Access Compliance Report

Public Rights-of-Way

Intersection ID: 30450	Main Street: STEELE_CREEK_RD	Cross Street: SMOKE_MONT_DR	Location: W
ADA ID: 7026EFDE57FB	Ramp Type: BlendTrans1	Initial Pass/Fail: Pass	Overall Compliance: No
Severity Score: 0			
Codes/Mitigation Info/Possible Solution		Field Measurements/Component Compliance

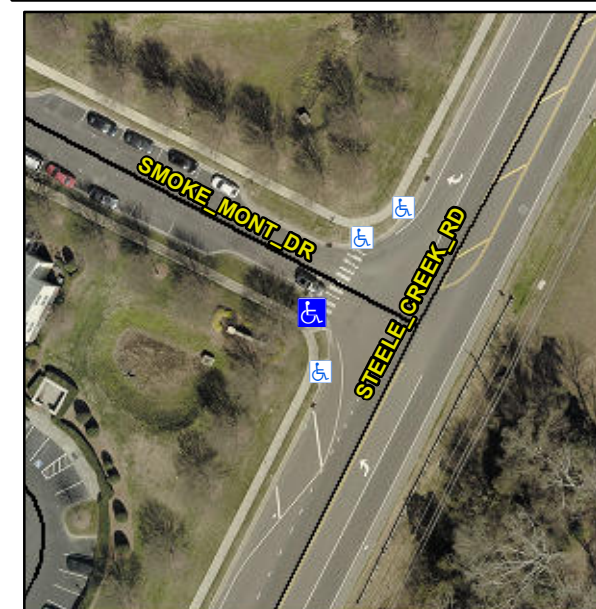
Not Found, R304.2.1

Yes	Ramp inside XWalk1?	Yes	N/A	Ramp inside XWalk2?	N/A
	Road Slope (%)	0.5		Clear Space?	Yes
	Road X Slope (%)	1.2	N/A	Clear Space to XWalk (in)	N/A
Yes	Any Obstructions?	No	Yes	Storm Grate/Utility Hazard?	No
	Obstruction Type			Storm Grate/Utility Type	
		N/A			N/A
			Yes	Surface Condition? (G/P)	Good
			No	Curb Slope (%)	20.9

Remove & Replace Curb Ramp With Two New Directional Ramps or Equivalent.
